COLORADO SPRINGS UTILITIES
WILLIAMS CREEK GENERATING STATION

CIVIL SITE EXHIBIT

EXH-CIV-SITE-001

V1_ Map Drawings.pdf Markup Summary

D. 1041 Map ← Maps 2 pages

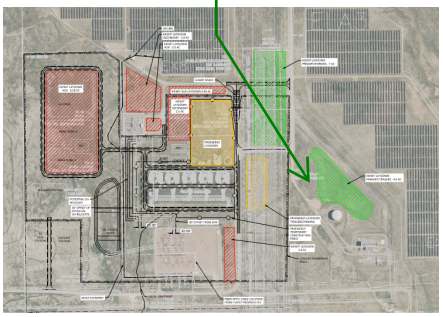
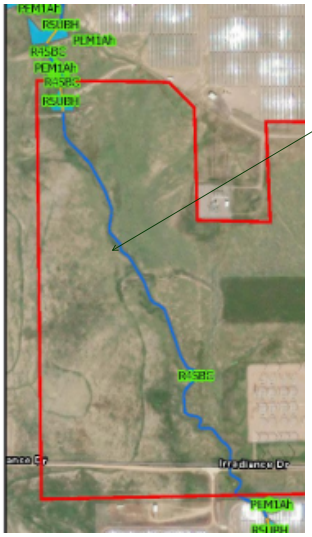
add this map to map drawings series so its easily accessed as it depicts the laydown areas and other info

Please identify the existing intermittent stream & riparian vegetation and state to be removed if that is the case on all map sheets in this map series

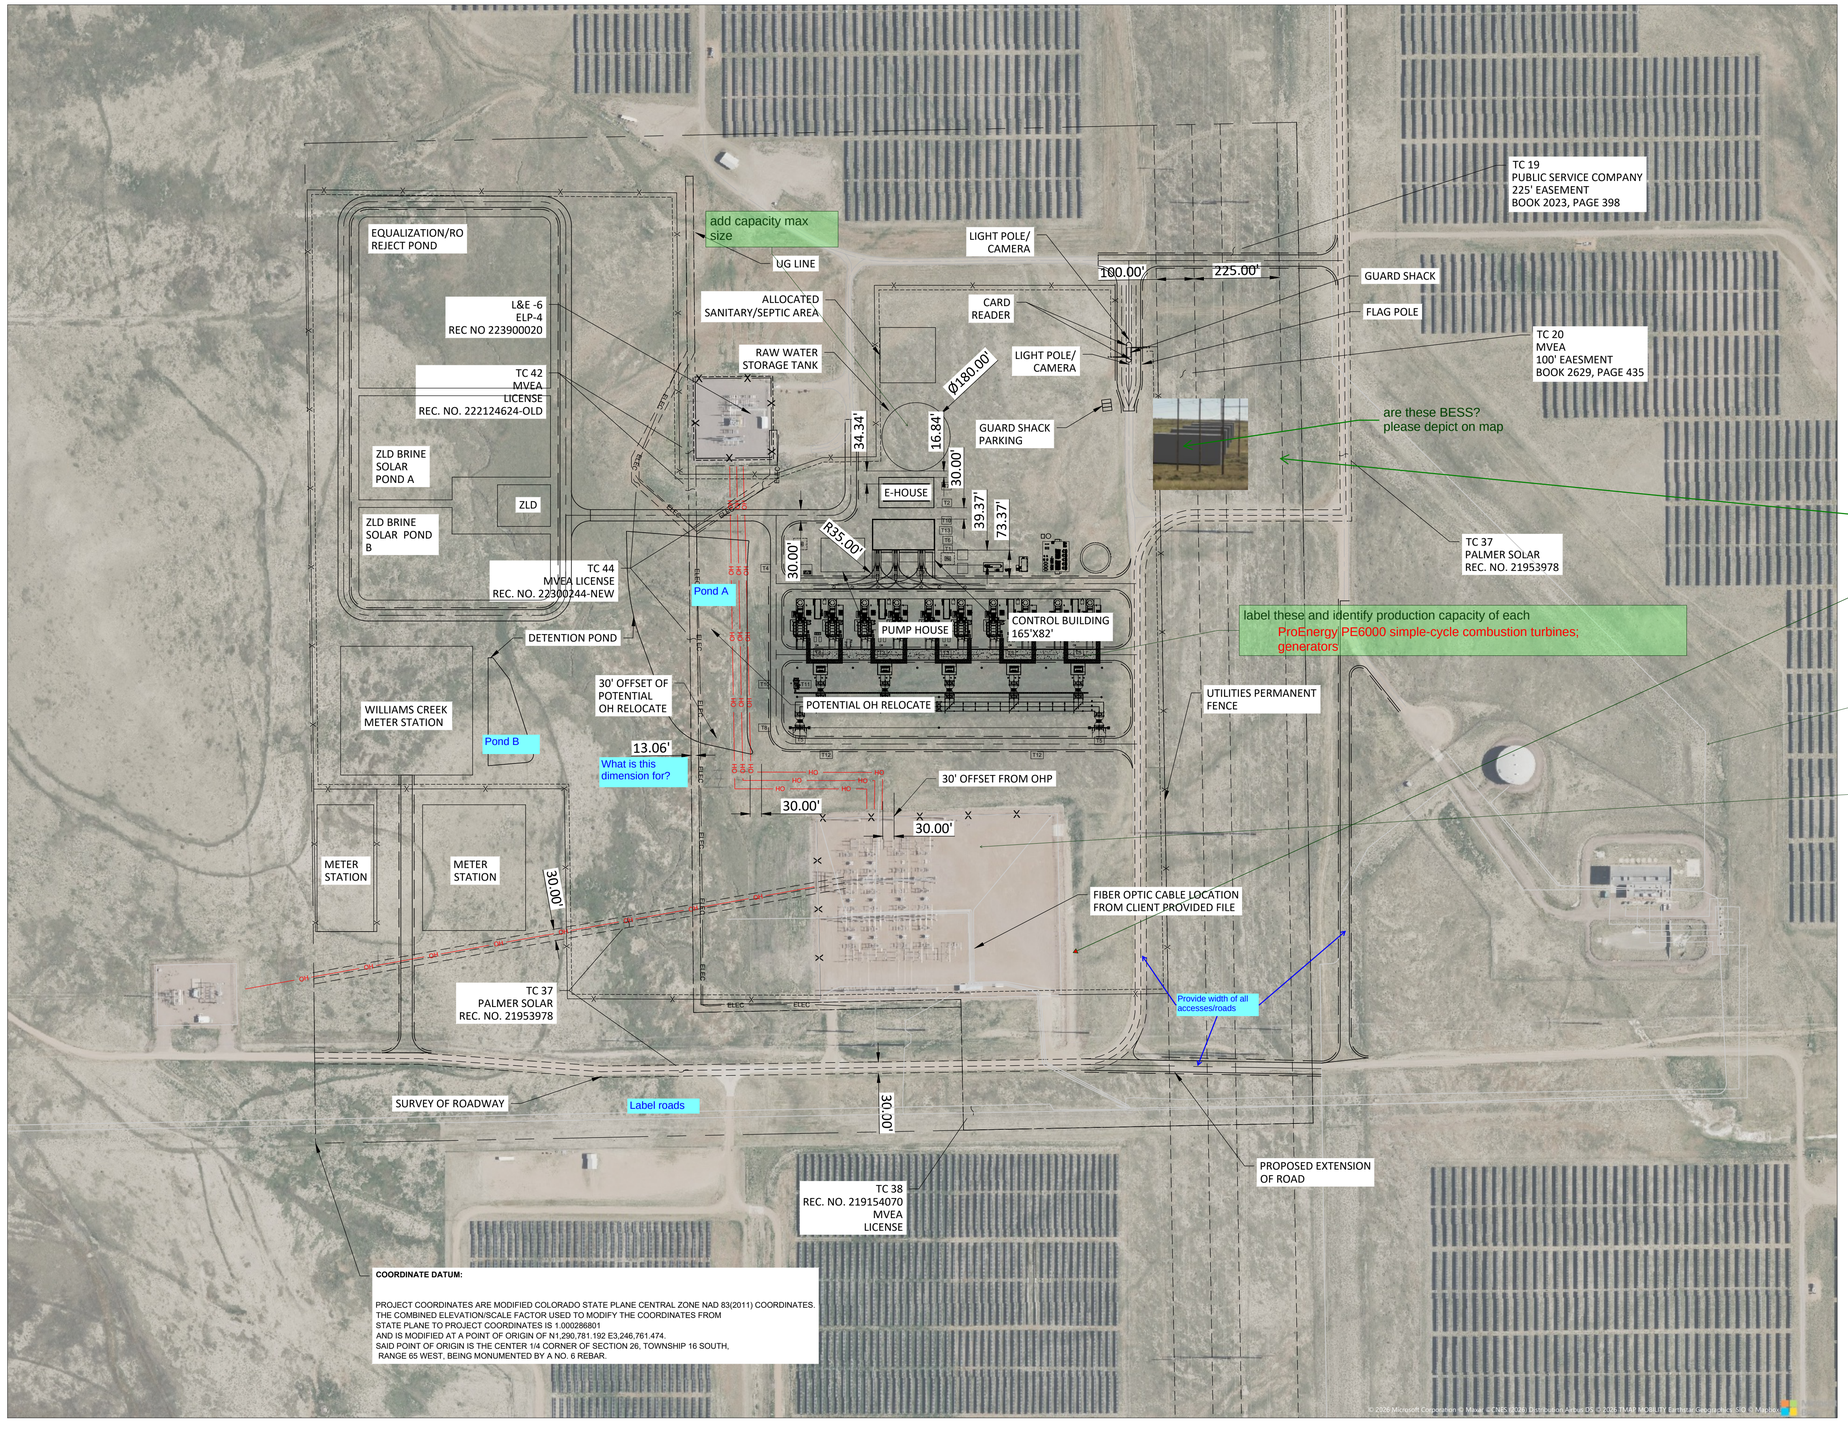
remove not for construction

Label roads

Pond B

Pond A

What is this dimension for?

Provide width of all accesses/roads

is there an expansion to the existing substation needed? Any transmission or carrier lines needed?

Please identify the existing lines capacity- color coded legend would suffice. It is difficult to identify existing verses proposed transmission and capacity lines

add capacity max size

label these and identify production capacity of each

are these BESS? please depict on map

Is the SDS line on this map? Please identify SDS in map drawing sheets pdf, as its referred to throughout application
